DEVELOPMENT APPLICATION ASSESSMENT REPORT

Application Number:	DA2020/0130
----------------------------	-------------

Responsible Officer:	Catriona Shirley
Land to be developed (Address):	Lot 100 DP 509808, 981 Barrenjoey Road PALM BEACH NSW 2108
Proposed Development:	Alterations and additions to a dwelling house
Zoning:	E4 Environmental Living
Development Permissible:	Yes
Existing Use Rights:	No
Consent Authority:	Northern Beaches Council
Land and Environment Court Action:	No
Owner:	Morris Symonds
Applicant:	Morris Symonds

Figure 2. Extent of the building height shown in pink.

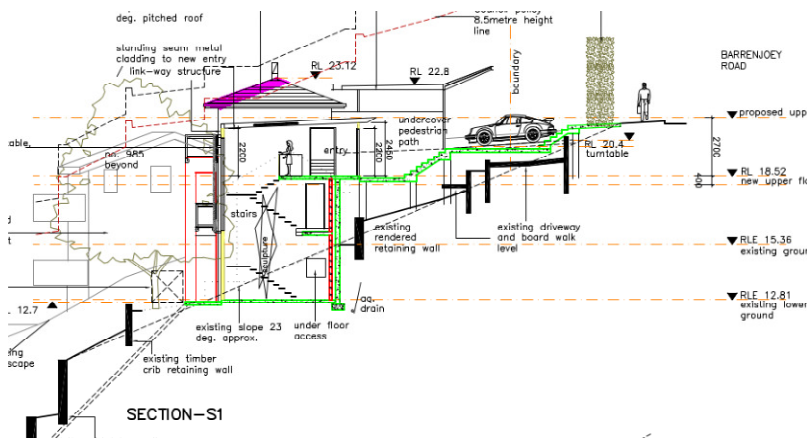
The site is subject to an 8.5m height control which is the vertical distance from Australian Height Datum (AHD) to the highest point of the building pursuant to the definition of building height under Clause 4.3 PLEP 2014. In the circumstances of this assessment, it is important to note that the site has been excavated to a depth of up to approximately 2.5m below AHD.

The maximum overall height of the new carport and associated roofing is compliant at 2.5m - 7.4m, and the maximum overall height of the north-west Pavilion is compliant at 8.5m.

The non-compliance is located at the south-eastern edge of the roofline (demonstrated in figure 1 and 2 above) due to the topographical nature of the site.

The portions of the development that exceed the 8.5m building height plane are limited in height and depth, as demonstrated in figure 1 and 2 above.

Figure 4: Demonstration of the proportion of the upper floor located below the Barrenjoey street level.

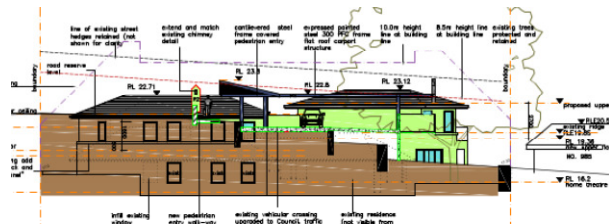
The front setback of the proposed Upper Level mimics the front setbacks of the existing 1 - 2 storey dwelling house. The siting of the dwelling house lower on the escarpment means the built form is not readily visible from the Barrenjoey Road streetview. The open style of the carport, provide a more open design rather than the enclosed garage examples along the Barrenjoey Streetscape.

The proposed works are also largely non-visible from the Barrenjoey Road streetview as the existing mature landscaped 3-4 metre high hedge along the Barrenjoey Road site frontage screens the built form, whilst continuing to provide glimpses of the Pittwater waterway. See

Figure 5. The south-eastern side boundary envelope non-compliance shown in pink.

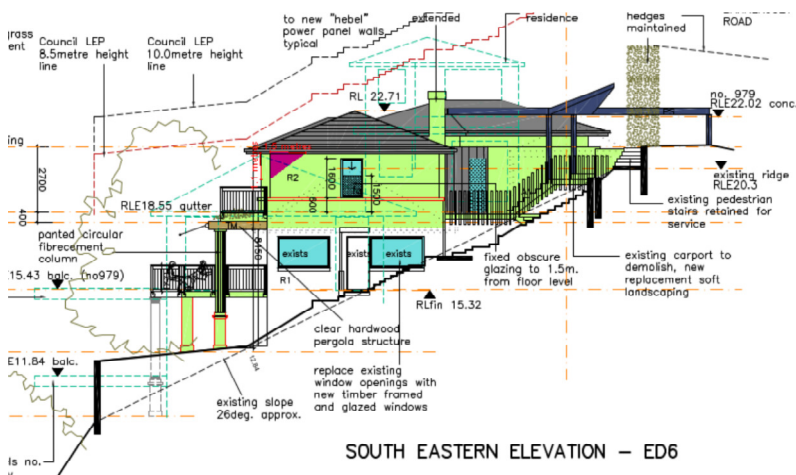
- South-East Elevation: up to 1.1m (height) and 1.2m (width).

The proposed First Floor introduces a new non-compliance with the building envelope control on the south-eastern elevation. The figure below shows the location and extent of the non-compliance.

As stated within the control “where the building footprint is situated on a slope over 16.7 degrees (ie; 30%), variation to this control will be considered on a merits basis”.
